**JOINT REGIONAL PLANNING PANEL
(Southern Region)**

JRPP No	2015STH023
DA Number	338-2015
Local Government Area	Queanbeyan- Palerang Regional Council
Proposed Development	Waste or Resource Management Facility
Street Address	172-192 Gilmore Road (Part Lot 1 DP 1169293), 7 Kealman Road (Lot 2 DP 1000911) 1 Bowen Place (Lots 348, 349 and 350 DP 8458) Queanbeyan West
Applicant/Owner	Wild Environment on behalf of SUEZ
Number of Submissions	<i>1st Round</i> 112 public submissions objecting to the proposal 3 petitions comprising 577 signatures 1 submission supporting the proposal – ACT Government <i>2nd Round following amendment</i> 26 public submissions which included 5 from new submitters
Regional Development Criteria (Schedule 4A of the Act)	Schedule 4A of Environmental Planning and Assessment Act 1979 Clause 8(c) Particular designated development Waste management facilities or works, which meet the requirements for designated development under clause 32 of Schedule 3 to Environmental Planning and Assessment Regulation 2000

Recommendation	Refusal
Report by	Jacinta Tonner -Queanbeyan-Palerang Regional Council

Figure 5: -Site Plan showing the proposed traffic circulation off Gilmore Road through the site onto Bowen Place.

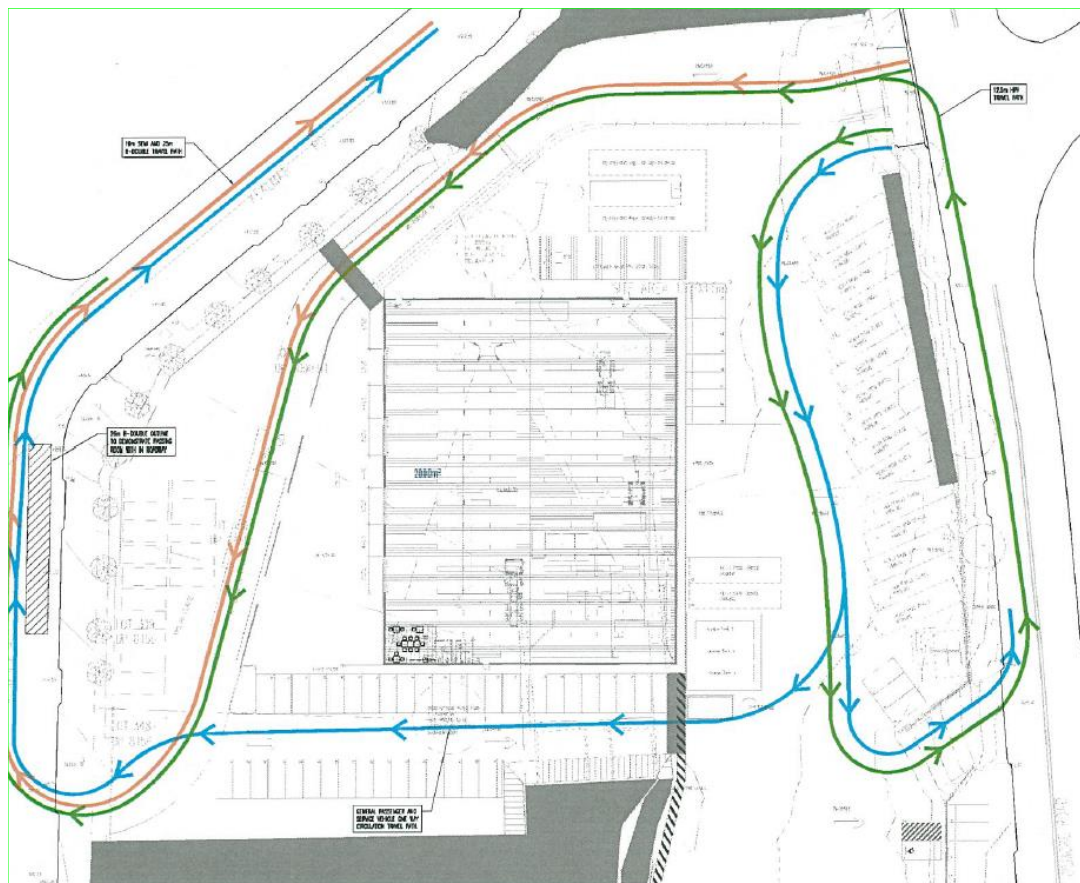
Assessment Comments - The applicant has proposed that all traffic enter Canberra Avenue via the signalised intersection on Gilmore Road. As such, the applicant was to satisfy Council that no truck could turn left out of Bowen Place into Kealman Road and that the adjoining land holder had to support the proposal as this would affect their business (Monaro Mix Concrete).

The applicant was able to provide written support from the adjoining business owner and allow for engineering works to extend the kerb in Bowen Place to inhibit trucks turning left and using the Kealman Road and Canberra Road intersection. Council further to this consider that a median in Kealman Road needs to be constructed to stop trucks mounting the kerb extension. Should approval be granted appropriate conditions will need to be applied.

Figure 6: Location of Additional Potential Sensitive Receivers

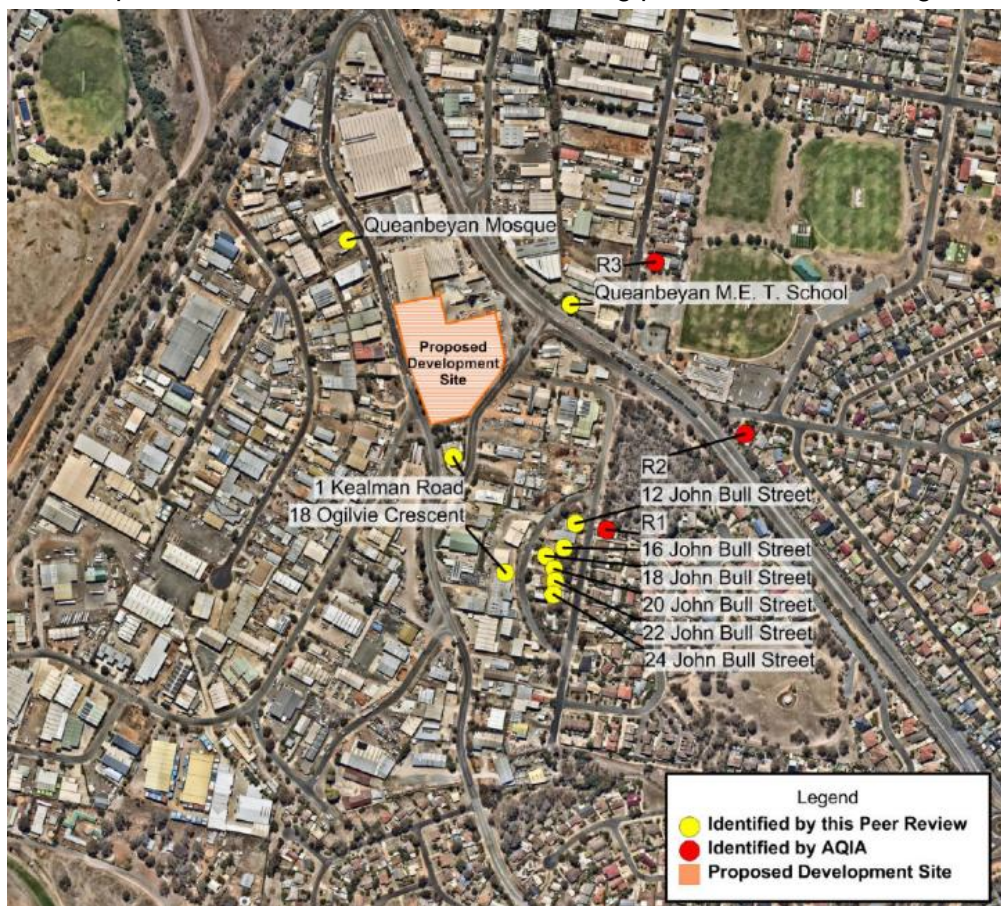
It is noted that additional receptors are located in the area zoned for industrial activity. These are all recognised by Council as approved premises.

The additional premises identified include the following premises shown in Figure 6 below:

The applicant's consultant has nominated use of Section 2.2.1 of the NSW Industrial Noise Policy which recommends that the industrial amenity criteria are applied to isolated residences within an industrial zone.
